Model: Model C- P1 Paper Feed Unit (G360)	Date: 7-Dec-04	No.: MG360001a
---	----------------	----------------

MB Correction

Modified Article: Environmental Correspondances		Prepared by: A. Ishiyama	
From: 1st Technical Support Sec. Service Support Dept.			
Reason for Modification:	☐ Parts catalog correction ☐ To facilitate assembly ☒ Part standardization	☐ Vendor change ☐ To improve reliability ☒ Other	☐ To meet standards ()
Modification Schedule:	From September '04 production

[G3925330: 5-35]**2.PAPER FEED DRIVE (G360)**

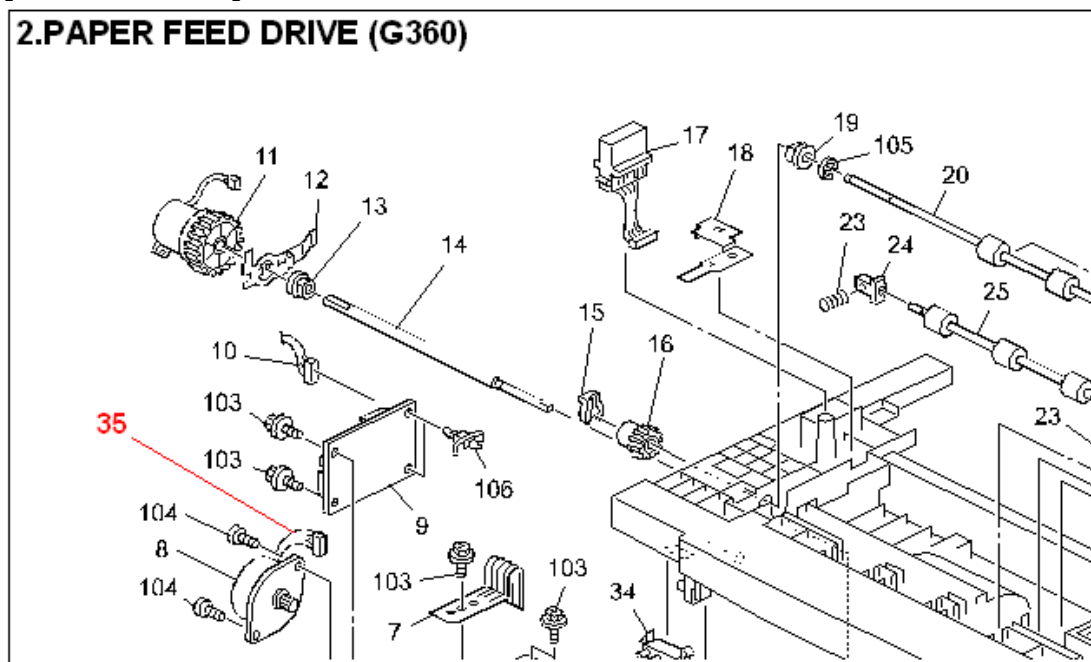
Old part number	New part number	Description	Q'ty	Int	Page	Index	Note
[Motor]							
C4085700		Stepper Motor DC24V	1→1	X/O	5	8	1
	➡ AX040216	Stepper Motor MM42: UD2A					
	➡ G3925330	Harness – Motor	0→1	-/-	5	35	1
[PCB]							
G3605100		PCB Ass'y	1→1	X/O	5	9	1, 2
	➡ G3605120	PCB – Bank : P2					
[Clutch]							
G3603250	G3923250	Magnetic Clutch : Paper Feed	1→1	X/O	5	11	1
[Spring]							
G0292657	G3922657	Compression Spring : Paper Feed	1→1	X/O	5	33	1
[Bracket]							
G3603221	G3603222	Motor Bracket	1→1	X/O	5	6	1
[Screws]							
AA143716	AA143820	Stepped Screw	1→1	X/O	7	46	4
G0044635	AA143824	Stepped Screw M3	1→1	X/O	7	23	4
G0124617	AA143544	Screw M3	1→1	X/O	9	49	4
G0487152	AA143822	Stepped Screw M3.5	1→1	X/O	9	29	4

Change: Material change, circuit board change (PCB).

1. To change the materials used in these parts (chromium, lead) to a non-toxic type.
2. To handle the faster ppm speed of the next model.

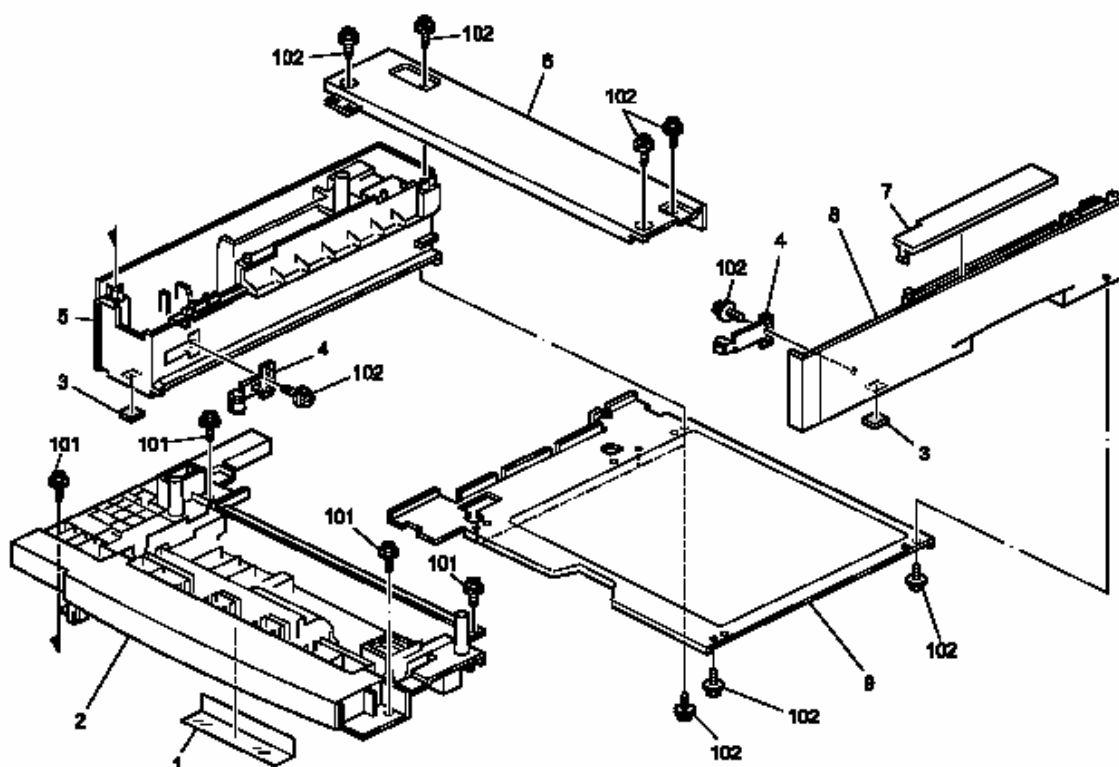
Old part number	New part number	Description	Q'ty	Int	Page	Index	Note
G0963053	G1022818	Tray Bottom Plate Adhesion	1→1	X/O	3	14	
G0292608	52152713	Base Pad	1→1	X/O	3	15

Change/Reason: The material used in these parts (lead) was changed to a non-toxic type.
